ARCHITECTURAL DRAWINGS

84 - 88 BIRRIGA ROAD
BELLEVUE HILL, NSW, 2023

PROPOSED NEW APARTMENT DEVELOPMENT OVER 2 BUILDINGS SET ON 2 ADJACENT LOTS,
INCLUDING 16 NEW APARTMENTS AND ASSOCIATED LANDSCAPING WORKS

2 DEVELOPMENT APPLICATION

1 HEIGHT PLANE DIAGRAM 01

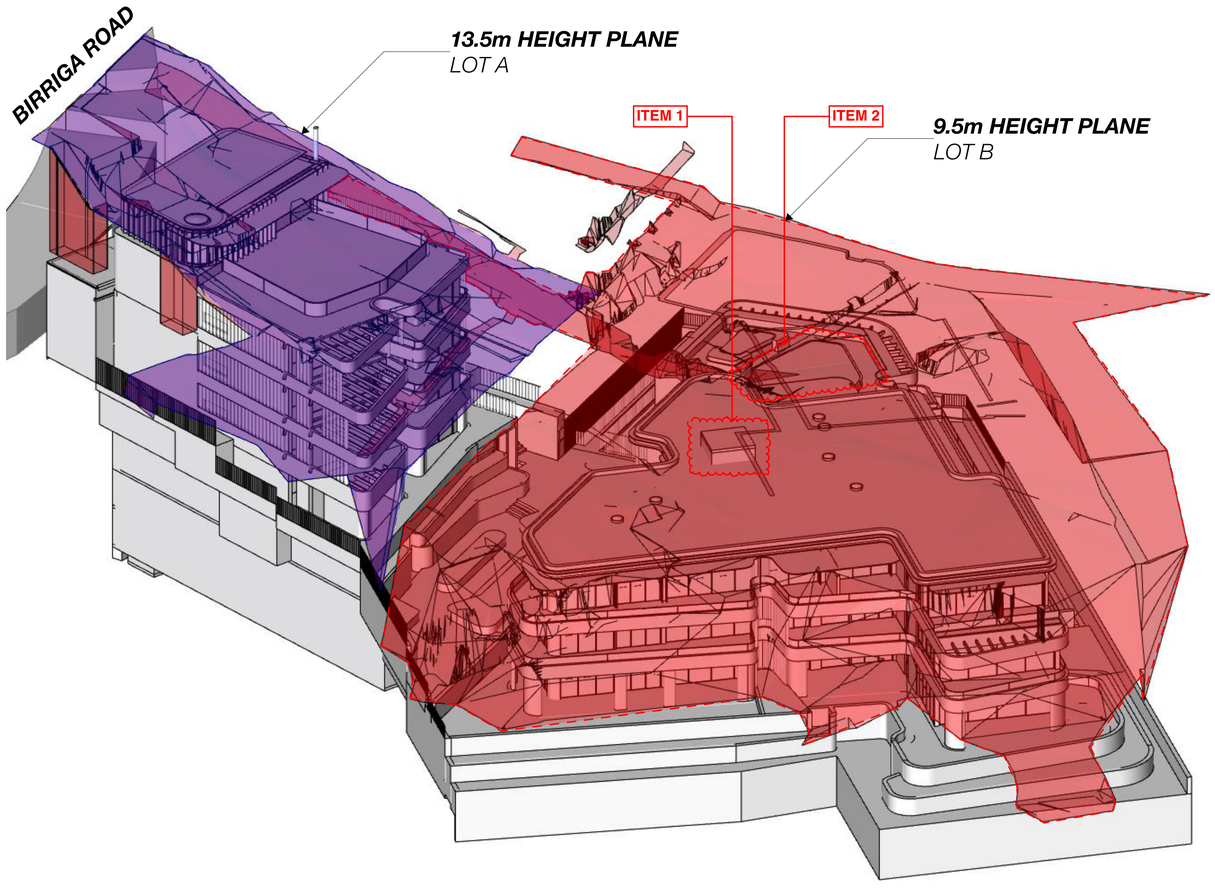
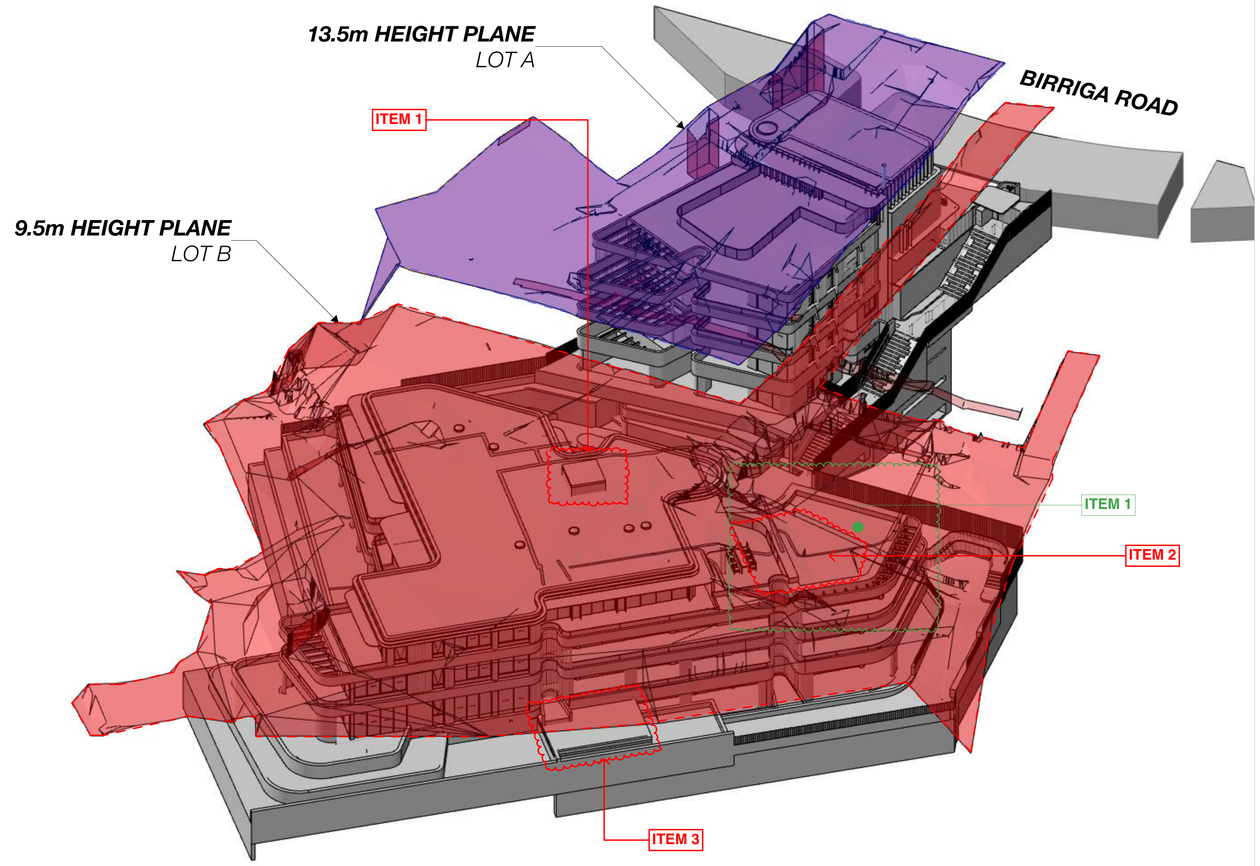
1. GREEN ROOF ADDED ADJACENT REDUCED AREA OF COMMUNAL ROOF TERRACE

1 - VIEW FROM THE SUN - JUNE 21st - 09:00am

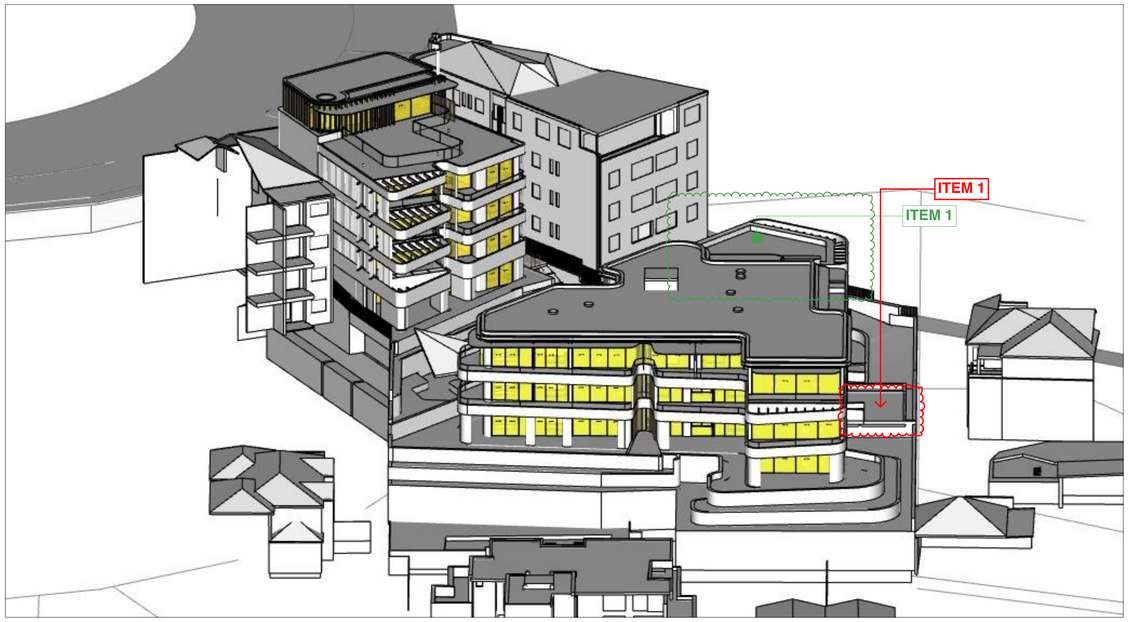
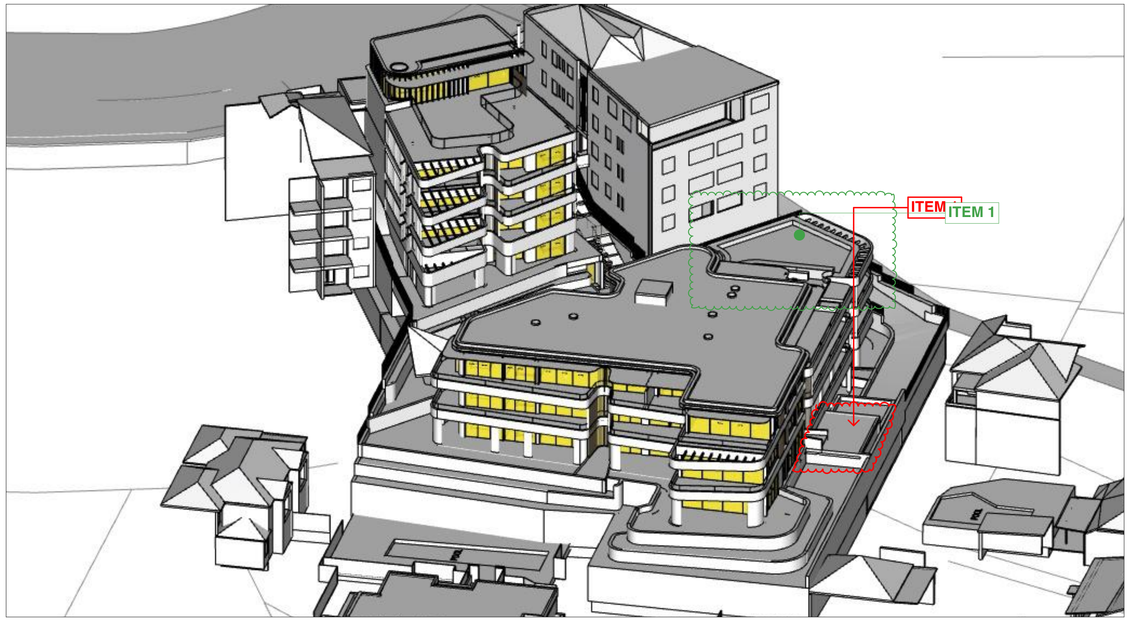
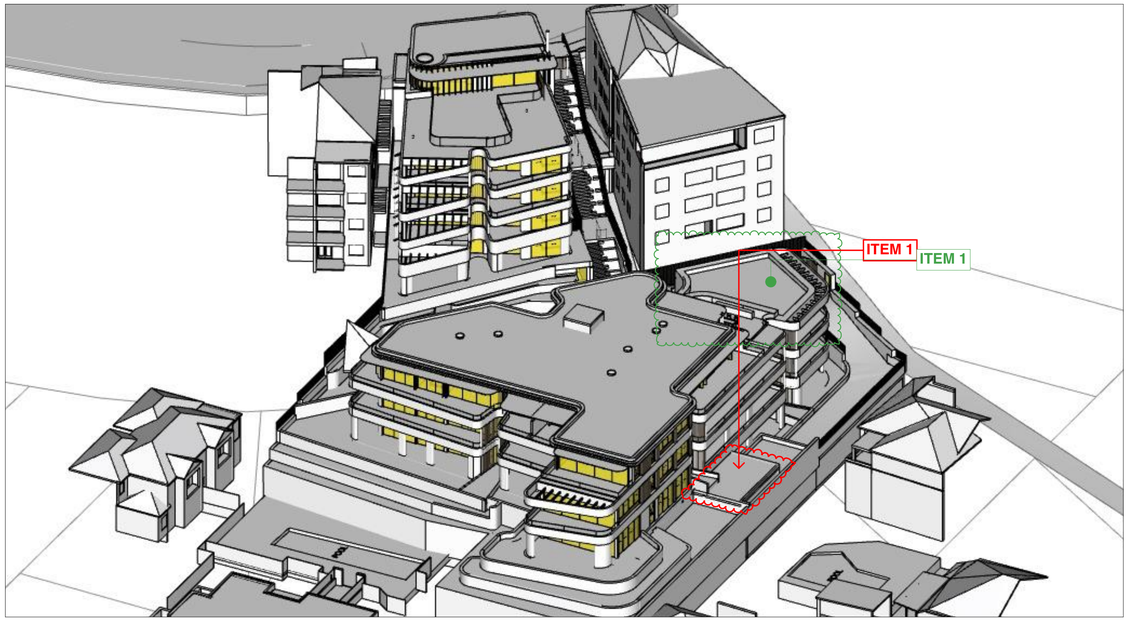
1. COMMUNAL OPEN SPACE TO ROOF OF BUILDING B REDUCED. **NO CHANGE TO SOLAR ACCESS NUMBERS PROPOSED**

1
-
VIEW FROM THE SUN - JUNE 21st - 12:00pm

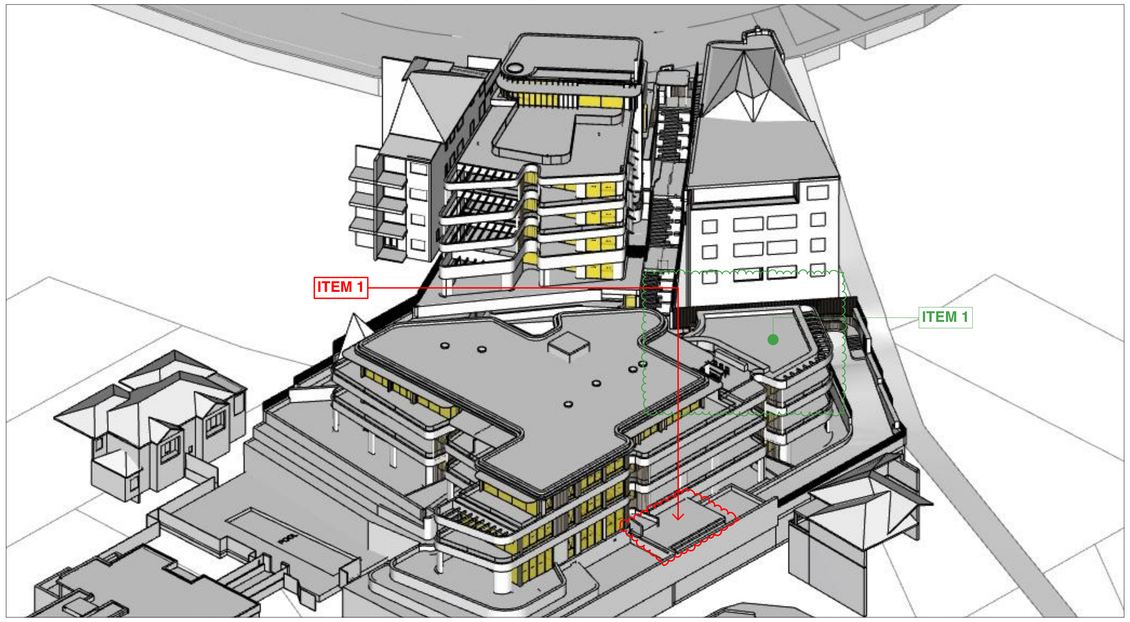
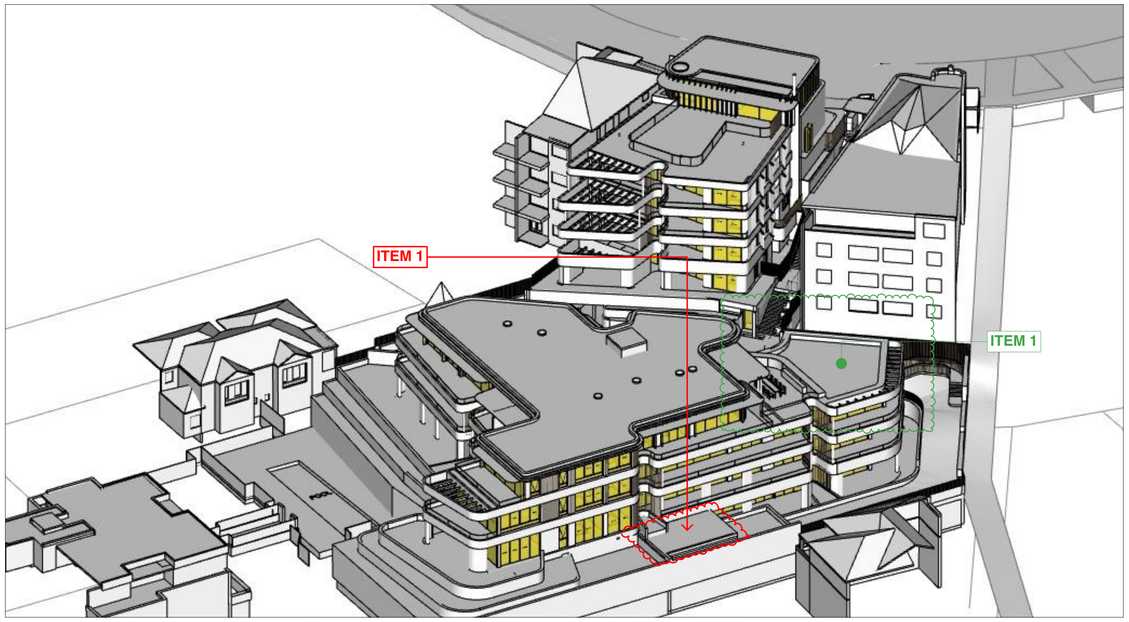
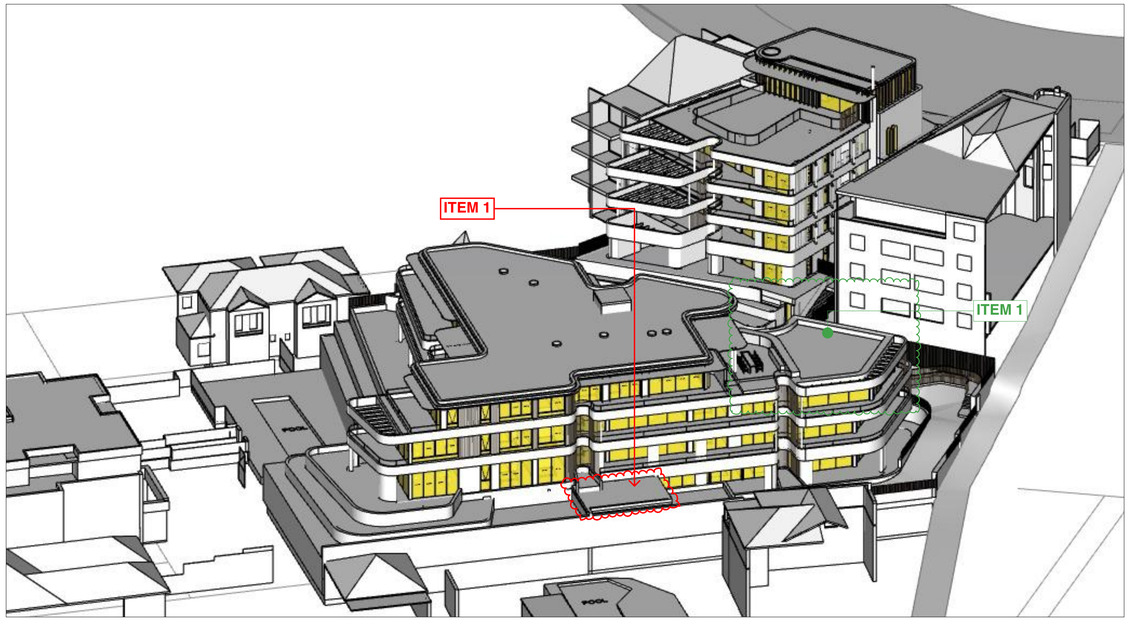
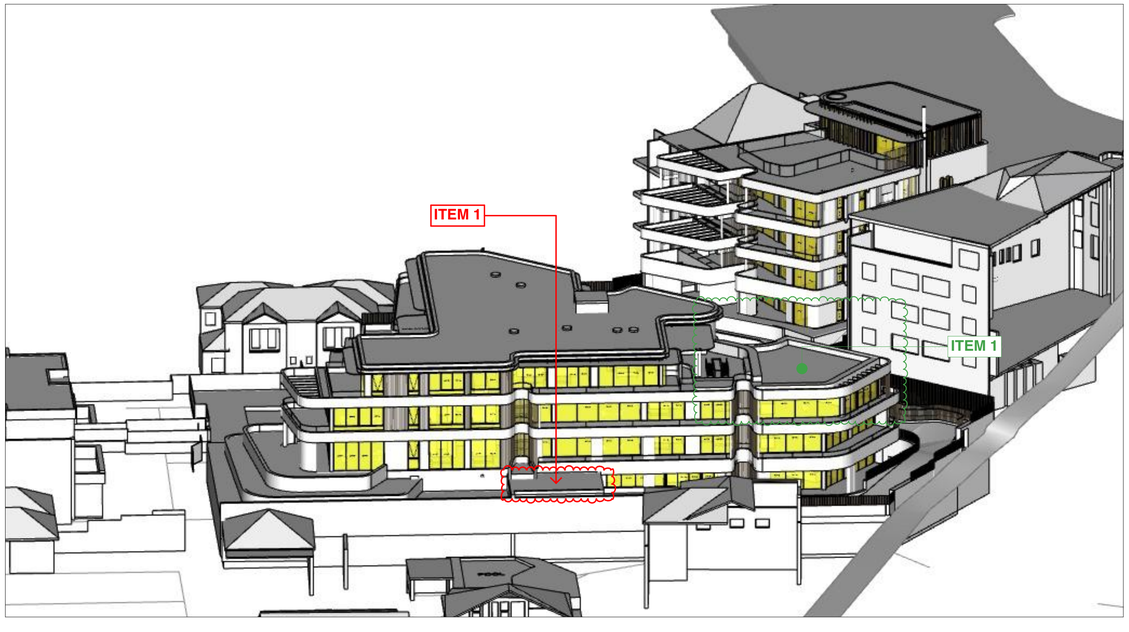
1. COMMUNAL OPEN SPACE TO ROOF OF BUILDING B REDUCED. **NO CHANGE TO SOLAR ACCESS NUMBERS PROPOSED**

1 BUILDING B : NORTH ELEVATION
1:300

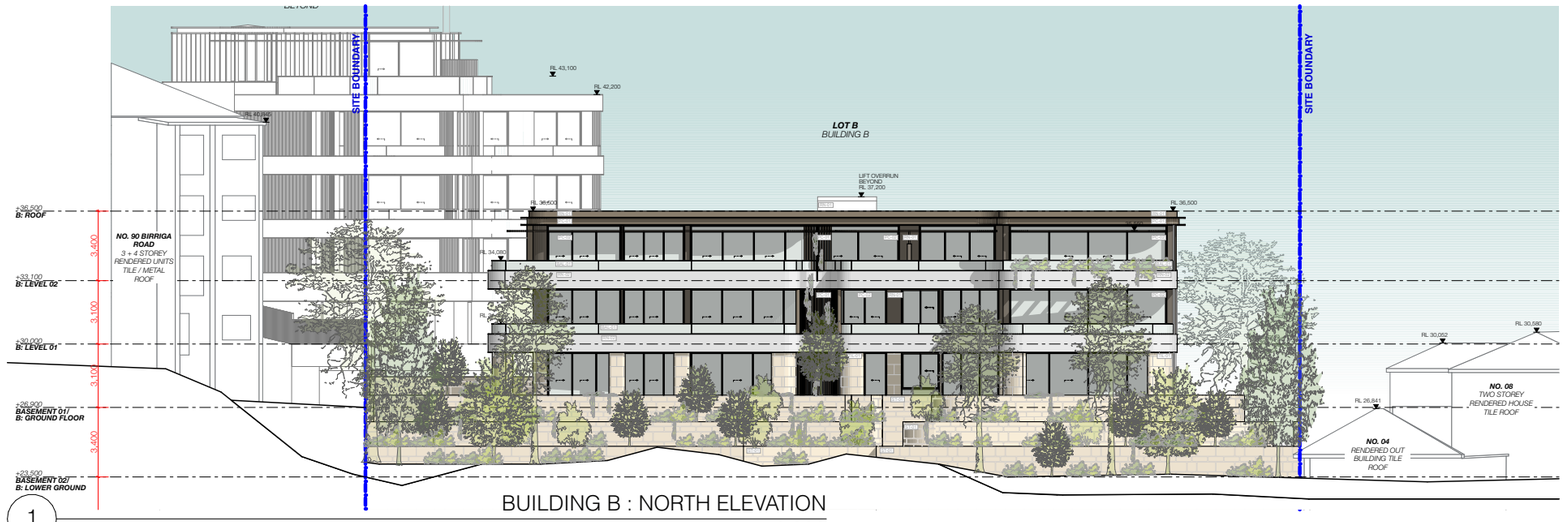
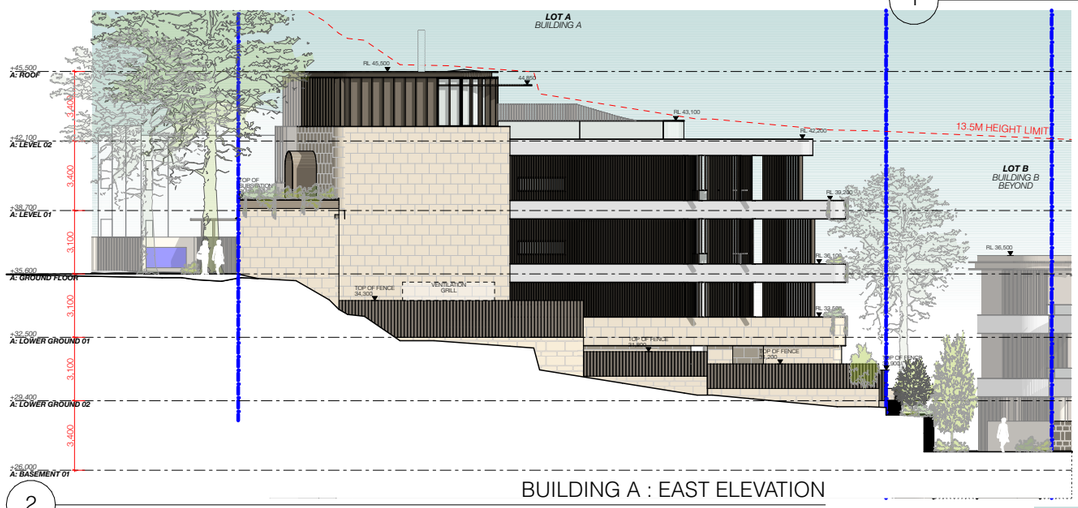
1. MINOR AMENDMENTS TO EXTERNAL ELEVATIONS.

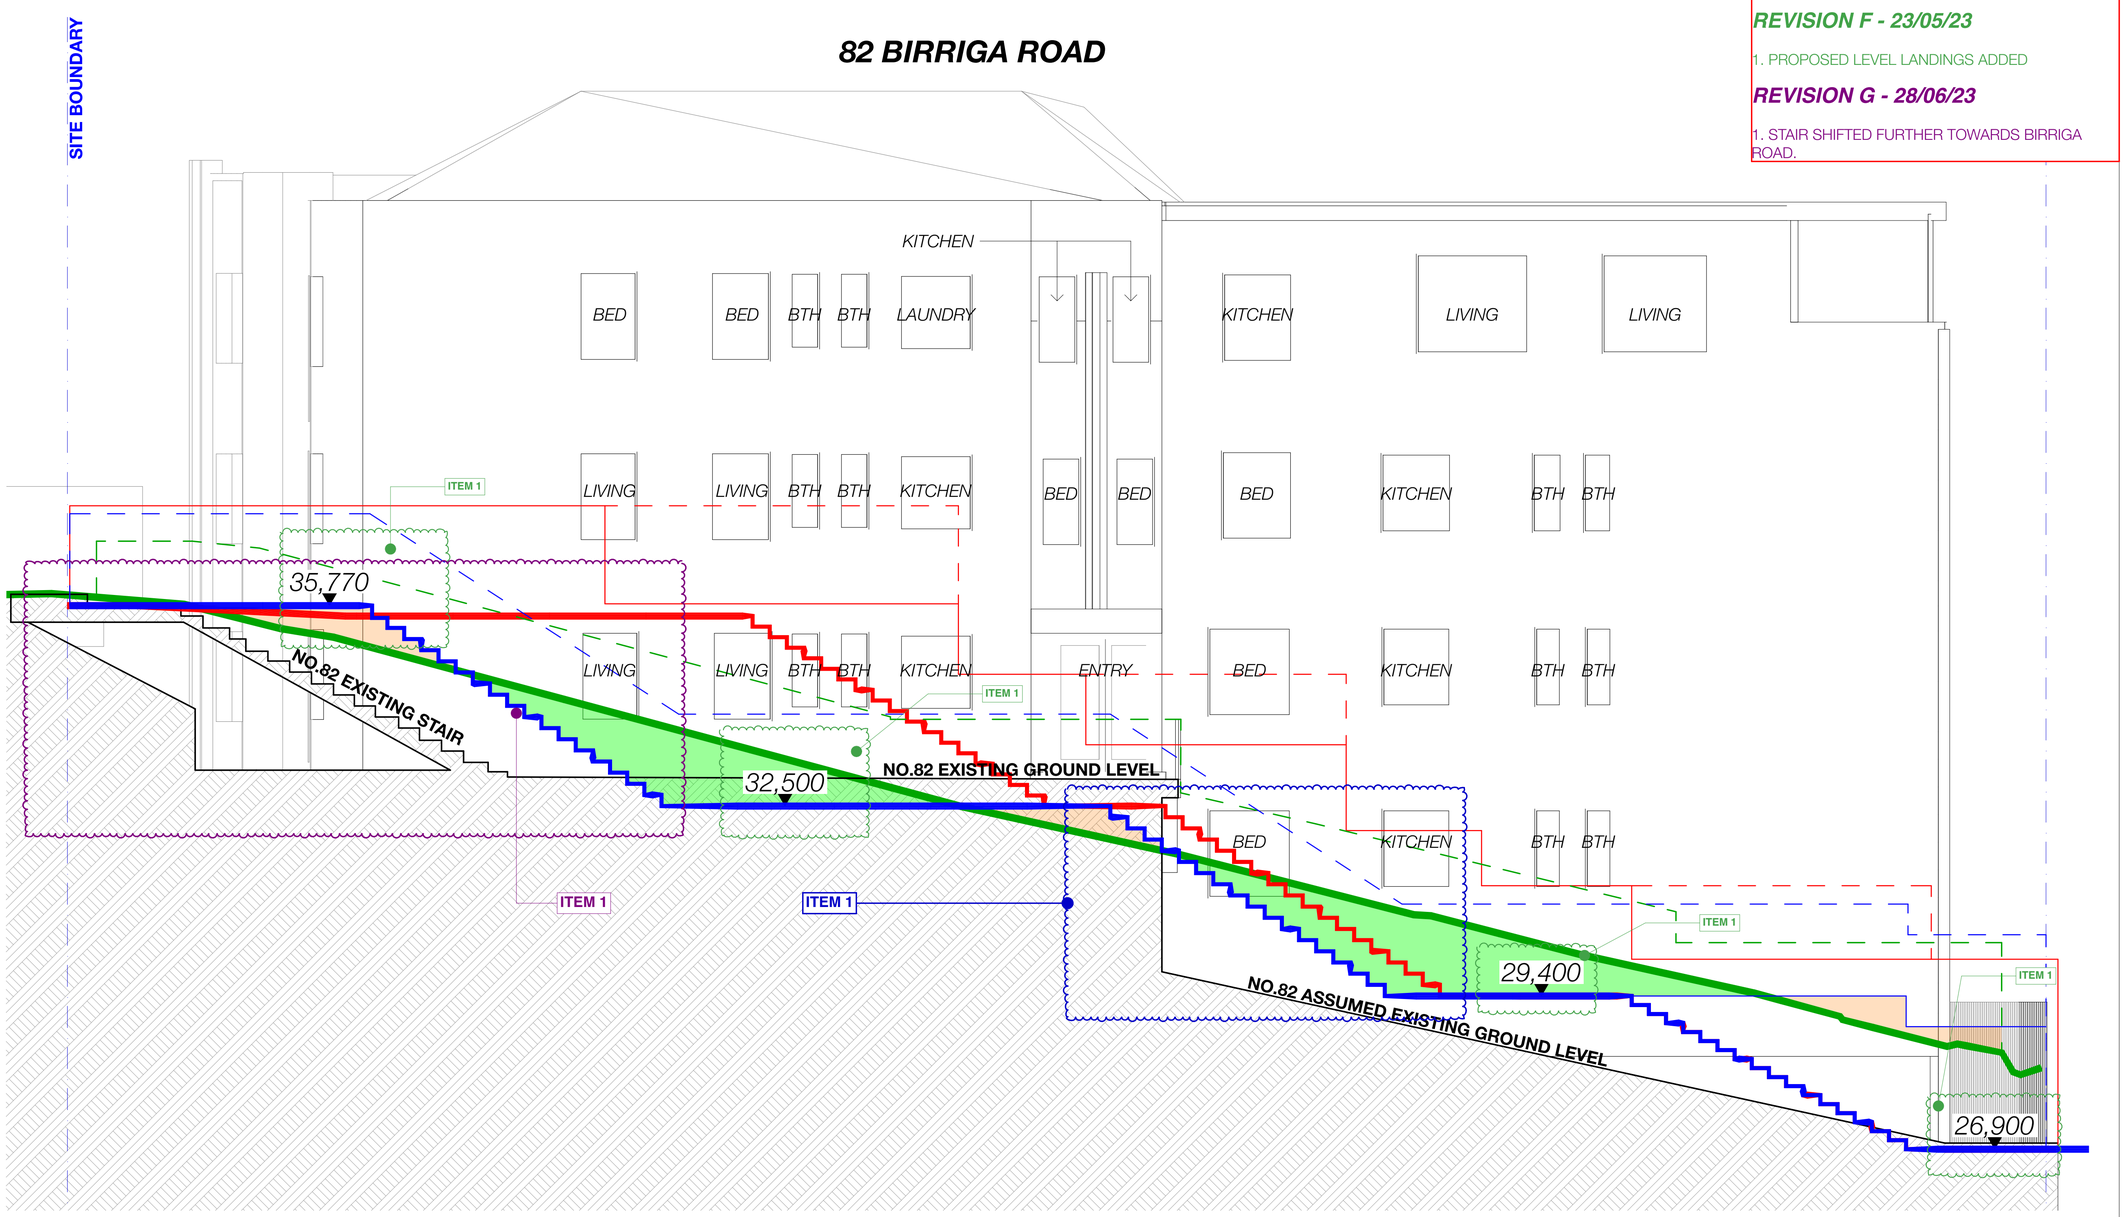
1. STAIR SHIFTED FURTHER TOWARDS BIRRIGA ROAD.
